# Office Action Summary

10/596,022

FURUKAWA ET AL.

## **DETAILED ACTION**

*Fig. 1F*

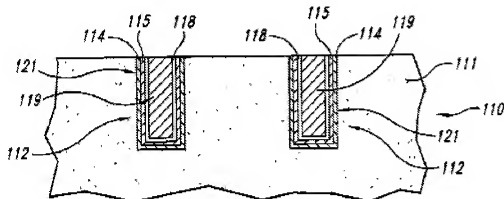
26. Regarding **claim 1**, figure 1A-1F and related text of Lee et al. discloses a substrate 110; a trench in said substrate; conductive material 115 (paragraph [0021]) lining said trench; and a trench conductor (conductive electrode) 119 (paragraph [0023]), surrounded by said conductive material filling said trench (paragraph [0022]), wherein said trench conductor (conductive electrode) 119 (paragraph [0023]) and said substrate 110 having a co-planar top surface.

Lee et al. does not disclose the conductive material is a multiple conductive carbon nanotubes.

However, in the same field of endeavor figure 1 of Lee teaches using multiple conductive nanotubes 100 as a capacitor electrode (paragraph [0024]).

Therefore, it would have been obvious to one of ordinary skill in the art at the time the invention was made to replace the conductive material 115 of Lee et al.'s device with multiple carbon nanotubes as taught by Lee in order to increase the storage capacity of the capacitor (paragraph [0006]).
